10/21/96 VACATION OF DRAINAGE/UTILITY  
EASEMENT-JYLNAD DENNIS ADDITION

AGENDA ITEM: IV.A.

Re: Drainage Easement #14 Bello  
More Filling Within This Easement

## REPORT/RECOMMENDATION

DENNIS RESIDENCE  
FIGURE 1

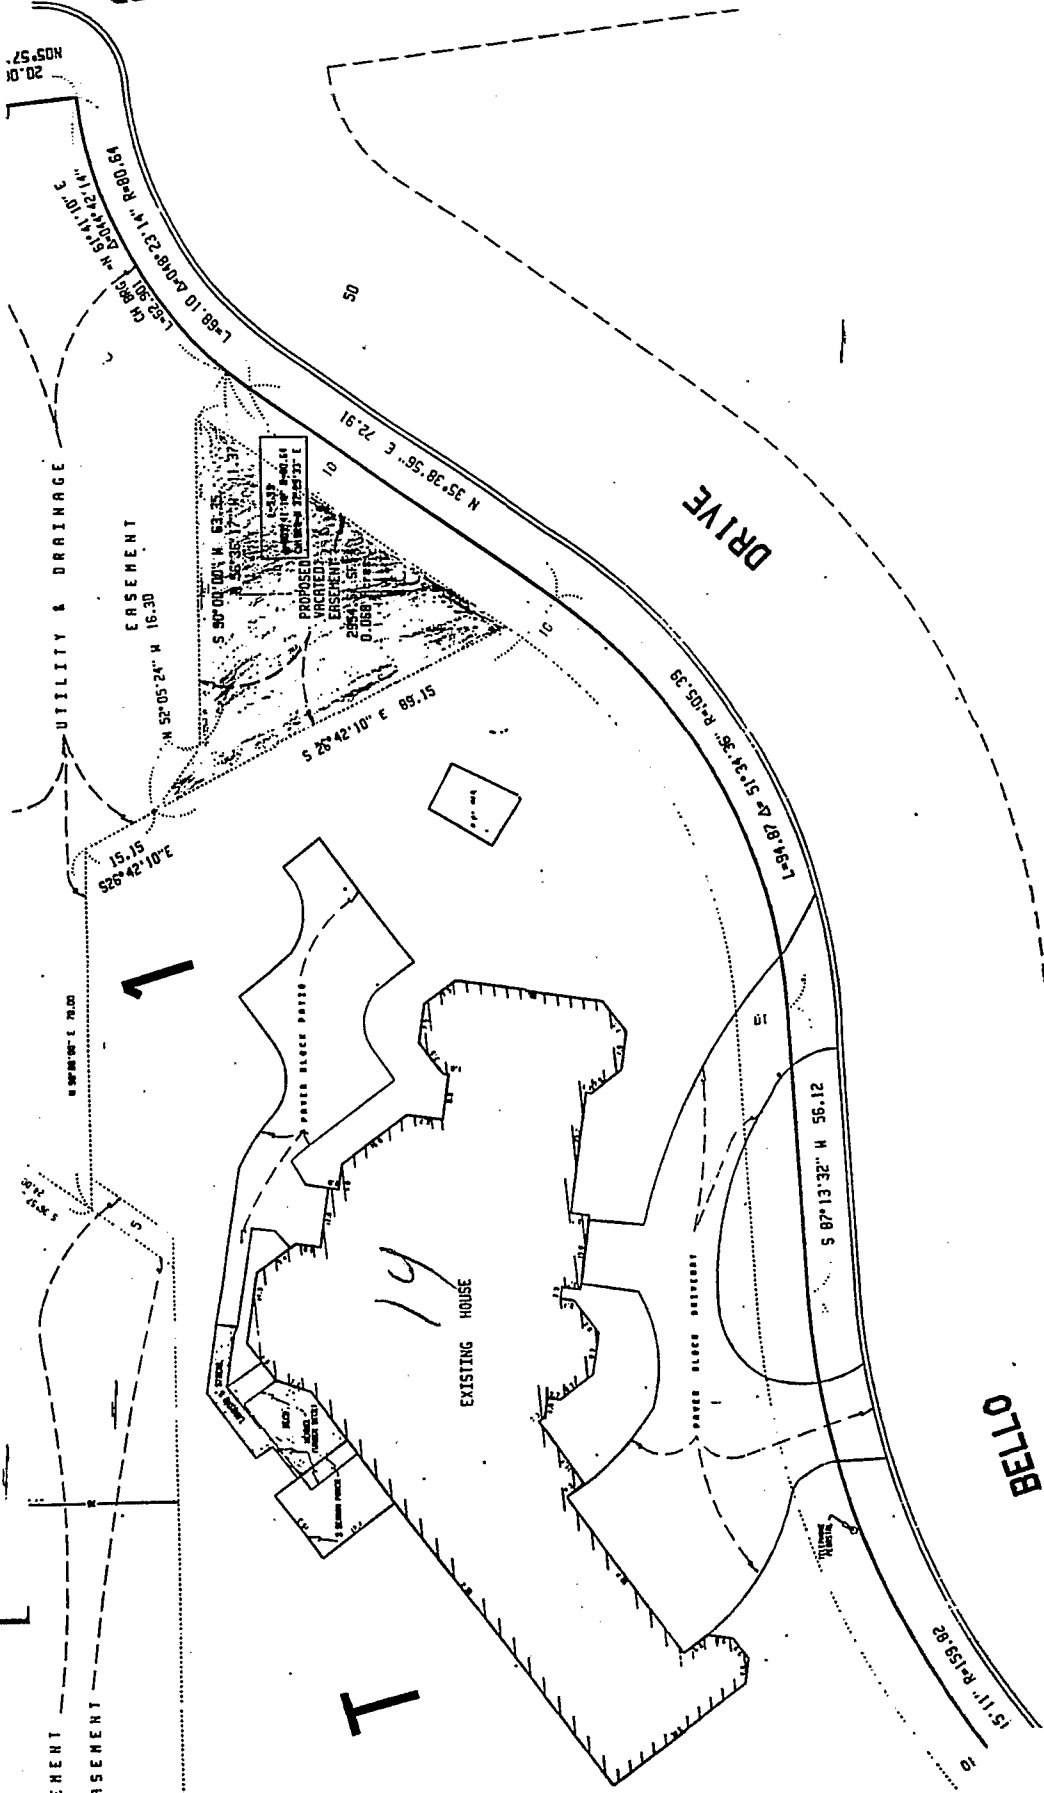
After hearing, if deemed reasonable, vacate a portion of the requested area above the 881.00 elevation to prevent any change in the current drainage area.

This issue was held over from the October 21st Council meeting to allow for the requesting parties to meet with the neighbors to the north of the site proposed for vacation. The meeting occurred with the homeowners at 6916 and 6920 Dakota Trail (the northerly neighbors) and the homeowner at 14 Bello Drive, Kevin Keenan and Dan Parks, homeowner, architect and engineer respectively of the requesting party. Even though the engineering study indicates that a small portion of the lower area drainage area could be vacated without adverse effect, staff would recommend not vacating any portion below an elevation of 881.00 feet above sea level. Staff has attached a 1974 topography map that shows the two low areas prior to development (see attached topography map). Both areas remain today, with the difference being that more hard surface area exists in the development so that a somewhat higher volume of water arrives in the low spots quicker. The homeowner immediately to the north at 6920 Dakota Trail reports that seepage problems exist now that did not earlier (see attached letter). Given that information, one should not alter the current status, even though engineering reports indicate otherwise.

Also, the architect for the homeowner at 14 Bello Drive has submitted how the portion above the 881.00 elevation would work if the City grants vacation of the utility area. The attached three exhibits are a plan view and two cross sections of the area east of the 14 Bello Drive residence to include the low area. The normal staff position on this type of request is to allow landscaping to occur on a utility easement as long as no structure exists, i.e., swimming pool, decks, etc. However, the homeowners at 6920 and 6916 Dakota Trail are concerned how the vacated utility area might appear from their backyards. Again, note the letter from 6920 Dakota Trail concerning potential use of the requested vacated area. After viewing both sides of the issue, staff does not have a strong recommendation on this issue. Council should conduct the hearing and determine whether to continue the hearing seeking more detail on the potential use, or act upon the request either favorably or to deny.
